SI-260505
Service-Information Turbocharger

Technical changes to the exhaust manifold, new EGR pipe and heat shield ?

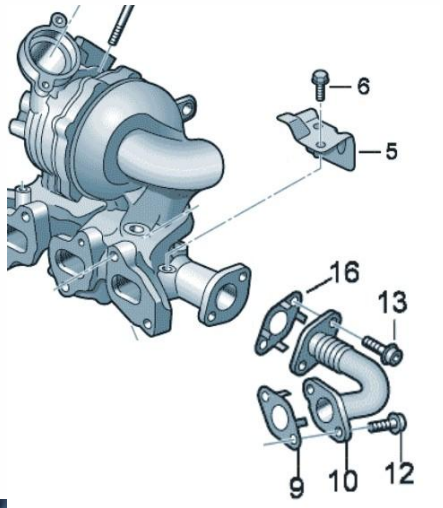
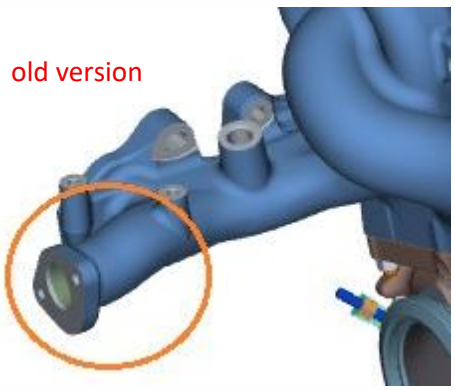
Introduction:
The vehicle manufacturer has made a significant modification to the turbocharger's exhaust manifold at the flange connection for the EGR pipe. Only the new version of the turbocharger is now being produced.

Note:
The following modifications apply to:
VW T6 models manufactured after 13.08.2018
VW Crafter und MAN TGE models manufactured after 14.05.2017

Instructions:
If the old version needs to be replaced, the vehicle manufacturer requires the following components:

Pos 5	1x	VW T6	03N 145 811 B	heat shield
	1x	VW Crafter	03N 145 811 B	heat shield
	1x	MAN TGE	65.08120-0001	heat shield
Pos 6	2 x	alle	N 106 884 02	screw M6x8
Pos 10	1 x	VW T6 (alle)	04L 131 521 **BF**	EGR-pipe
	1x	Crafter Schaltgetriebe	04L 131 521 **BF**	EGR- pipe
	1x	Crafter Automatik	04L 131 521 **BG**	EGR- pipe
	1x	MAN Schaltgetriebe	65.08153-00**12**	EGR- pipe
	1x	MAN Automatik	65.08153-00**13**	EGR- pipe
Pos9/16	2 x	alle Modelle	03L 131 547 P	seal
Pos12	2 x		N 910 268 02	screw 8x20
Pos13	2 x		N 910 461 02	screw 8x22
